SCHOOL OF LAW

Interdisciplinary Environmental Clinic

July 20, 2015

Re: 2015 Monitoring Network Plan

Figure 1. Modeled SO₂ design values in the vicinity of the Rush Island Energy Center.

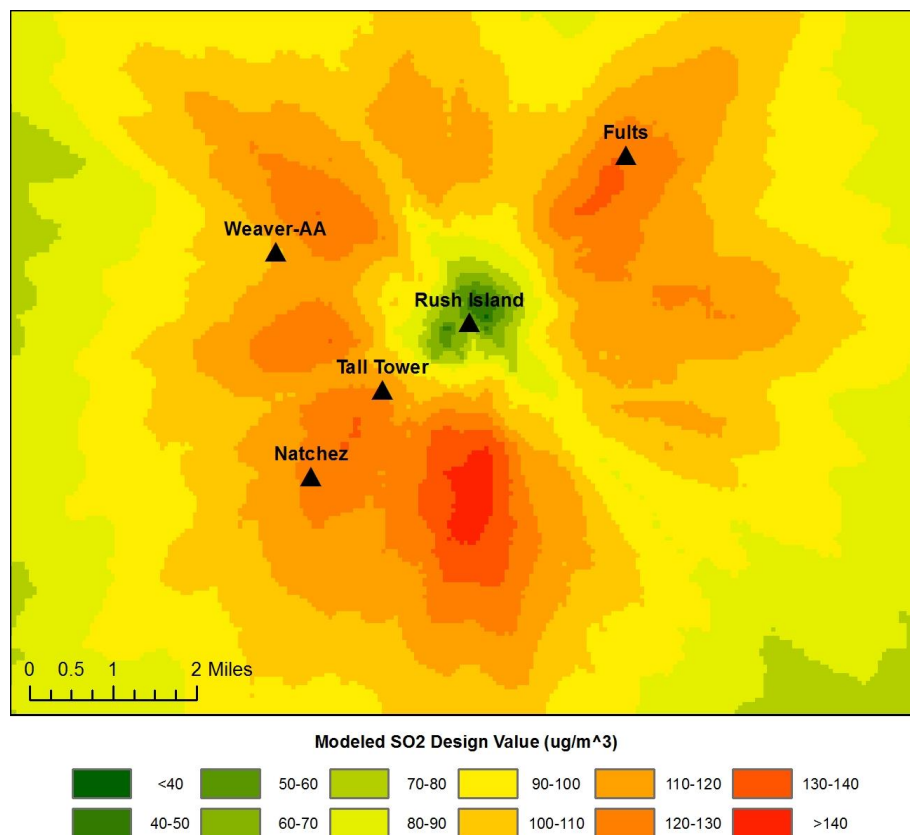
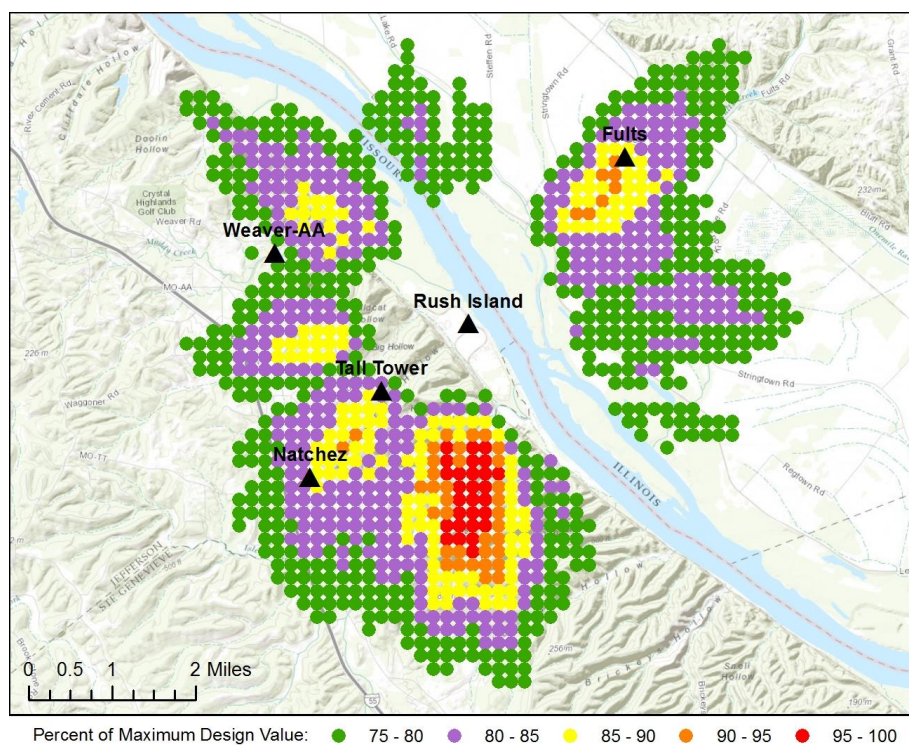
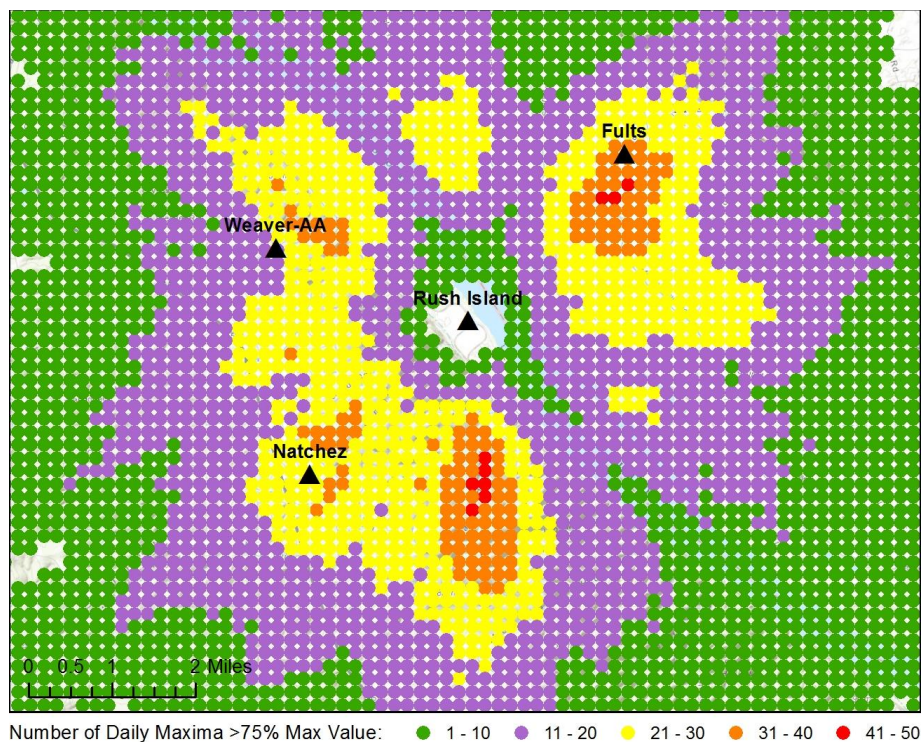
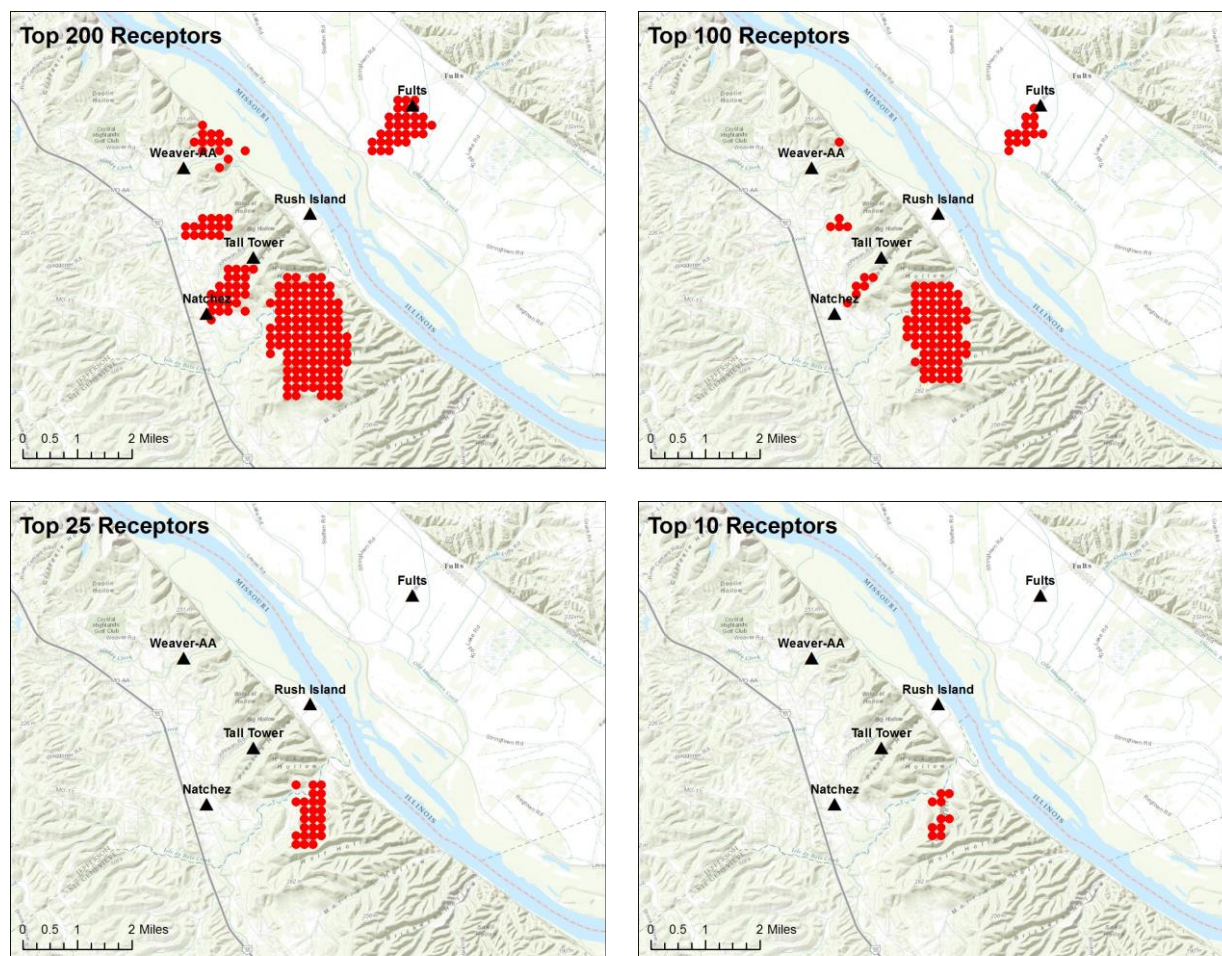
Figures 1 through 4 all reveal a strikingly similar pattern regarding the areas where peak 1-hour SO_2 concentrations are expected to occur around the Rush Island Energy Center. There is a large area due south of the plant where modeled design values are the highest (in excess of 95 percent of the maximum modeled design value), where modeled maximum daily 1-hour concentrations frequently exceeded 75 percent of the maximum modeled design value, and where over half of the top 200 receptors (including all of the top 25 and three quarters of the top 100) are located. There are also four other areas where modeled design values are slightly lower but still very high (in excess of 85 percent of the maximum modeled design value), where modeled maximum daily 1-hour concentrations frequently exceeded 75 percent of the maximum modeled design value, and where the rest of the top 200 receptors are located. These four areas, located northeast, northwest, west, and southwest of the plant, plus the area south of the plant where modeled design values are the highest, are where Ameren's modeling predicts peak 1-hour SO_2 concentrations are expected to occur. Monitoring stations located in these areas would have the greatest chance of identifying peak SO_2 concentrations in ambient air, which is the primary objective of source-oriented monitoring and an absolute necessity when monitoring to assess

compliance with the NAAQS. However, none of Ameren's proposed monitoring stations is located in any of these areas of highest expected concentrations.

The most glaring omission is that there is no proposed monitoring station in the large area of highest expected concentrations south of the plant. This omission renders the proposed monitoring network inadequate for its intended purpose of assessing compliance with the NAAQS because a) NAAQS violations are most likely to occur in this area, and b) violations could occur in this area even when concentrations are below the NAAQS in other high concentration areas, given that the modeling predicts lower SO₂ concentrations in those areas. Ameren's Monitoring Stations Analysis claims that this area is "not accessible" because it hosts an industrial plant (Holcim). The Analysis does not indicate whether Ameren sought Holcim's permission to site a monitor on the Holcim property, and does not delineate the Holcim property boundary in terms of the modeling results. In other words, it does not document the claim that this large area of maximum expected concentrations is inaccessible for monitoring. Nor does it evaluate the nearest non-Holcim site that might be available.

We urge DNR to reject the proposed monitoring sites and require Ameren to add a monitoring station in the highest concentration area due south of the plant as well as to relocate the proposed Fults, Natchez, and Weaver-AA monitoring stations to the optimized locations shown in Figure 5. We also urge DNR to require Ameren to 1) rerun the air dispersion model described in the report using Rush Island's actual hourly emissions; 2) evaluate the effects of nearby interactive sources (including, at a minimum, River Cement, St. Gobain Containers, Holcim, Mississippi Lime, Dynegy's Baldwin Energy Complex, and Ameren's Meramec Energy Center) on modeled peak concentration/high frequency areas; and 3) evaluate the appropriateness of using meteorological data from the Cahokia, Illinois airport instead of Doe Run Herculanum given DNR's determination that the latter is more representative of the modeled area.⁷ We further urge DNR to require any necessary adjustments to the proposed monitoring network based on the results of these analyses.

Figure 5. Modeled design values, receptors with design values ≥ 75 percent of the maximum modeled design value, and proposed monitoring station locations.

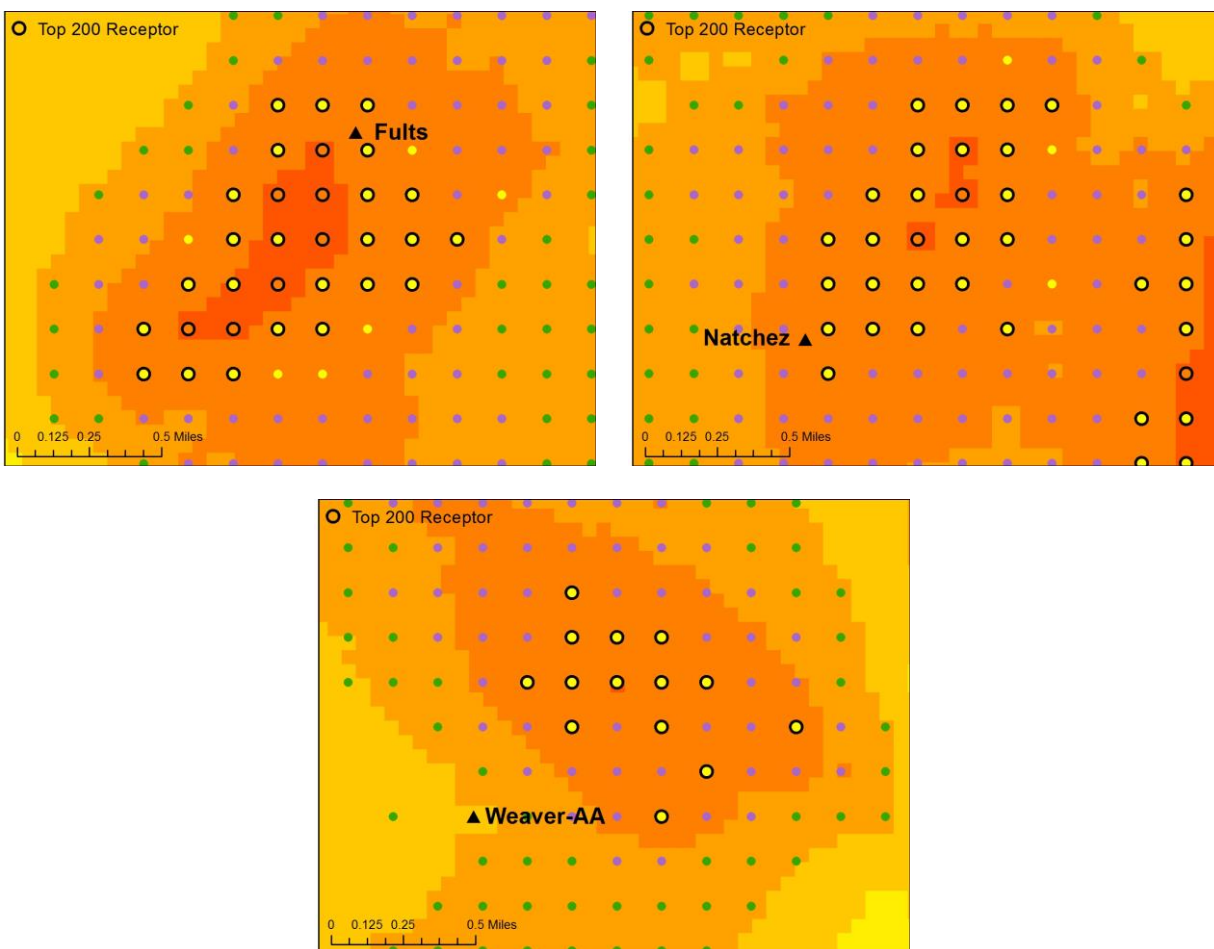
Fults – Of the three proposed monitoring stations, the Fults monitoring station is closest to an area where peak 1-hour SO₂ concentrations are expected to occur. However, moving the monitor less than one kilometer southwest of its current location would move it from an area with modeled design values in the 120-130 ug/m³ range to an area with modeled design values in the 130-140 ug/m³ range and place it near the center of a small group of receptors with modeled design values equal to 90-95 percent of the maximum modeled design value (the receptors

surrounding its current location generally have modeled design values equal to 85-90 percent of the maximum modeled design value). The entire area is floodplain/agricultural and Ivy Road, oriented northeast-southwest, runs through the middle of it, making the proposed optimized location as accessible as Ameren's proposed location and equally easy to provide power to.

Natchez – The Natchez monitoring station is outside/on the outer edge of an area where peak 1-hour SO_2 concentrations are expected to occur. Moving it approximately one kilometer northeast of its current location would move it from an area with modeled design values in the $120\text{-}130 \text{ ug/m}^3$ range to an area with modeled design values in the $130\text{-}140 \text{ ug/m}^3$ range, and place it between a pair of receptors with modeled design values equal to 90-95 percent of the maximum modeled design value (the receptors surrounding its current location have modeled design values equal to 80-90 percent of the maximum modeled design value). It would also move it to an area where higher concentrations are expected to occur with slightly greater frequency. The proposed optimized location is accessible via transmission right of way, and power is available along Dubois Creek Road to the south-southwest.

Weaver-AA – The Weaver-AA station is located completely outside of all areas where peak 1-hour SO₂ concentrations are expected to occur. Modeled design values at its location are only in the 100-110 ug/m³ range, and it is surrounded by receptors with modeled design values equal to just over 75 percent of the maximum modeled design value. Moving the monitor just over one kilometer east-northeast of its current location would place it in an area where modeled design values are 15-20 ug/m³ higher, in the midst of a slightly dispersed group of receptors with modeled design values equal to 85-90 percent of the maximum modeled design value. At this optimized location, concentrations in excess of 75 percent of the maximum modeled design value are expected to occur roughly twice as often as at Ameren's proposed Weaver-AA location. The proposed optimized location is readily accessible via State Highway AA, and power is available along the highway.

Figure 6. Current and optimized locations of the Fults, Natchez, and Weaver-AA monitoring stations

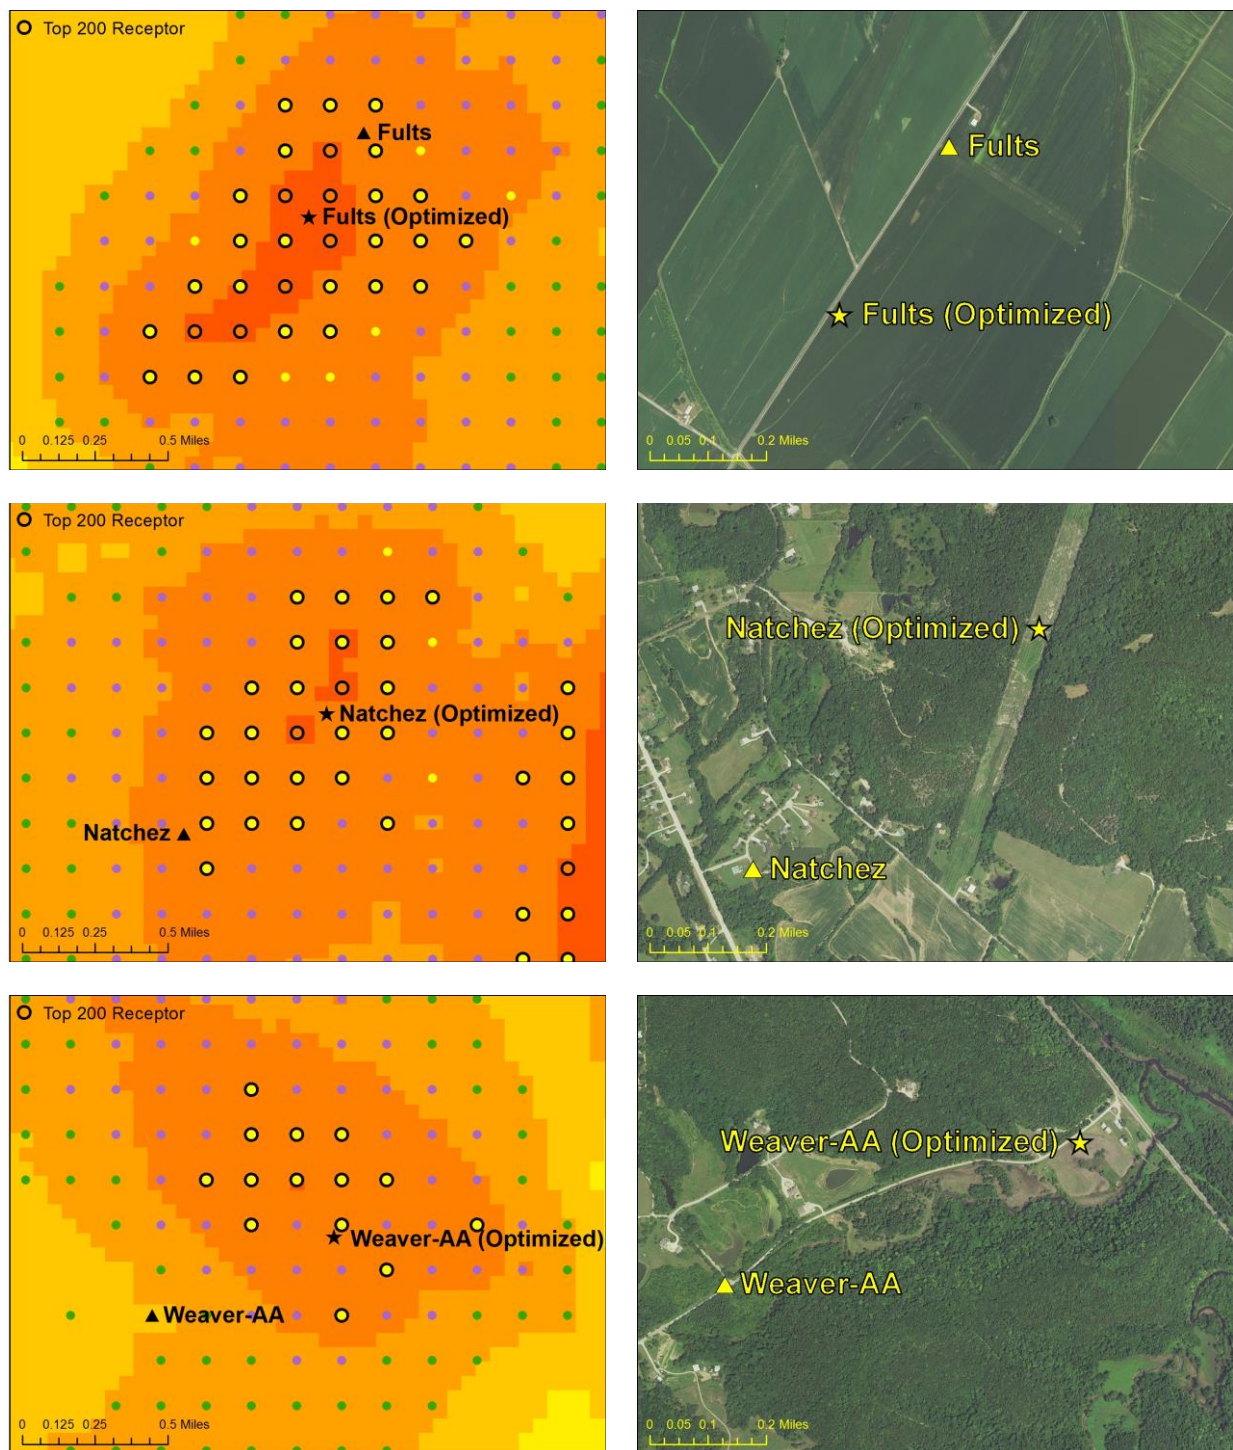
Figure 6 compares the locations of Ameren's proposed Fults, Natchez, and Weaver-AA monitoring stations with optimized locations more likely to record maximum SO₂ concentrations in the area.
